Subject: AP1000 Response to Proposed Open Item (Chapter 3)

AP1000 Response to Proposed Open Item (Chapter 3)

RAI Response Number: OI-SRP3.11-CIB1-01
Revision: 0

As a result of the NRC comments and observations during the subject review Westinghouse did a review of DCD Section 3.11, Appendix 3D, and supporting documents for other inconsistencies and discrepancies as an extent of condition review. The DCD changes identified from this review are identified below.

DCD – Appendix 3D – page 46 – Table 3D.5-5 – Accident Environments

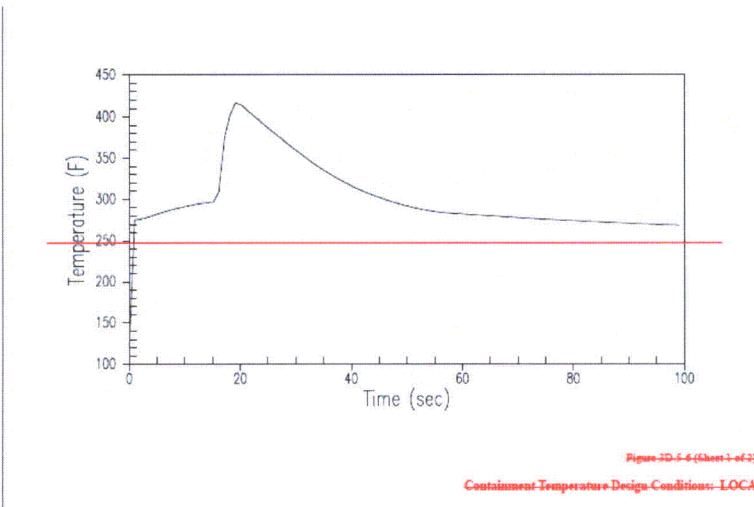
Table 3D.5-5	
ACCIDENT ENVIRONMENTS	
(See Table 3D.5-1 for environmental zones)	
Zone 1 - Inside Containment	
Temperature and , pressure and relative humidity Submergence as applicable up to elevation 110'6" Radiation	See Figures 3D.5-8 6 and 3D.5-7 See Figures 3D.5-2 through 3D.5-5
Zones 2, 3, 4, 6, 7, 8, 9, 11	
(Same as abnormal - see Table 3D.5-4)	
Zones 5 and 10 - Outside Containment	
MSIV Compartments	
Temperature, pressure and relative humidity Radiation	See Figure 3D.5-9 8 See Figures 3D.5-4 and 3D.5-5

DCD Appendix 3D – Page 61 – Figure 3D.5-9 (Sh. 1 of 2) “MSIV Compartment Response to MSLB”

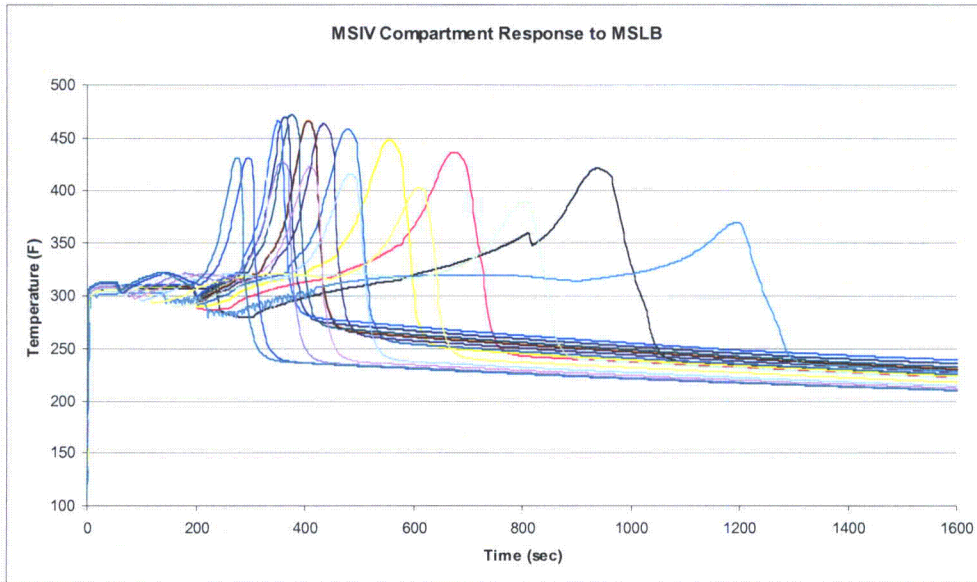
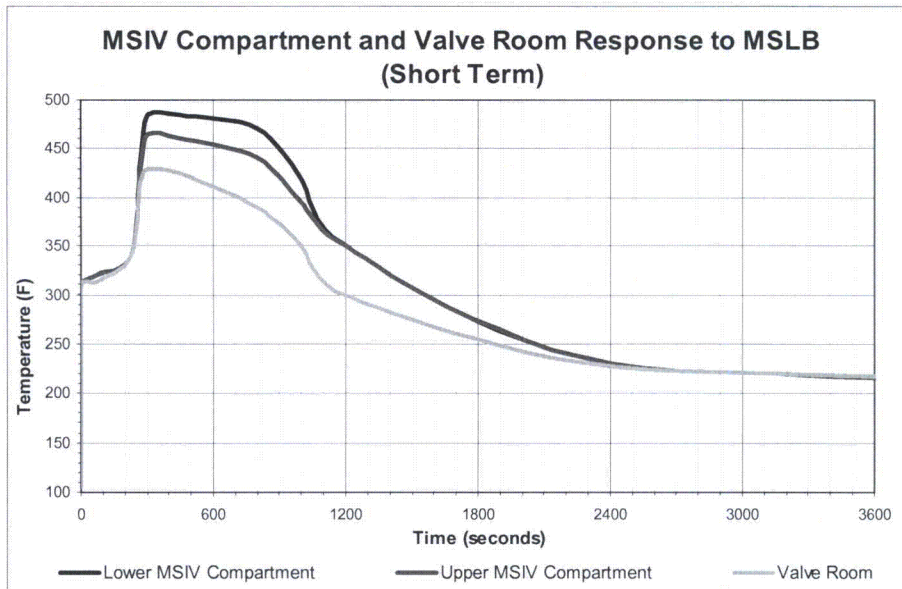
Note: This figure represents bounding curves of varying break sizes and power levels.

Figure 3D.D-3

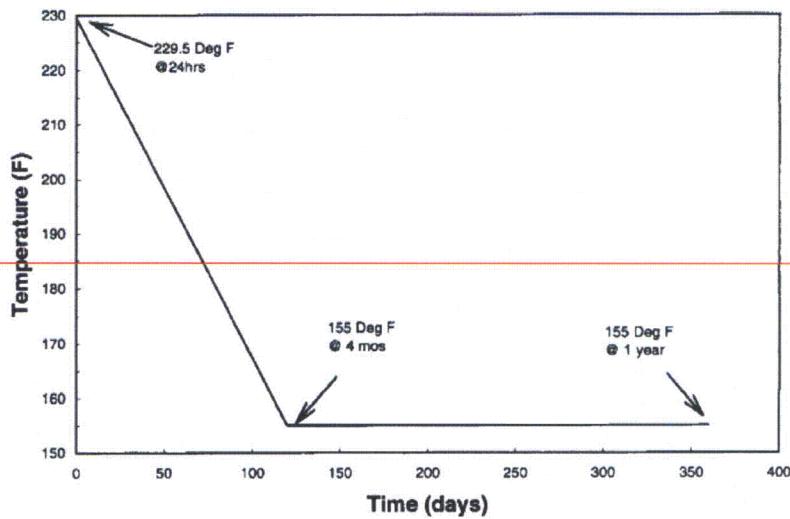
DCD Appendix 3D – page 3D-106 – Attachment D – Figure 3D.D-3 “Post Accident Temperature Profile”. To be deleted.
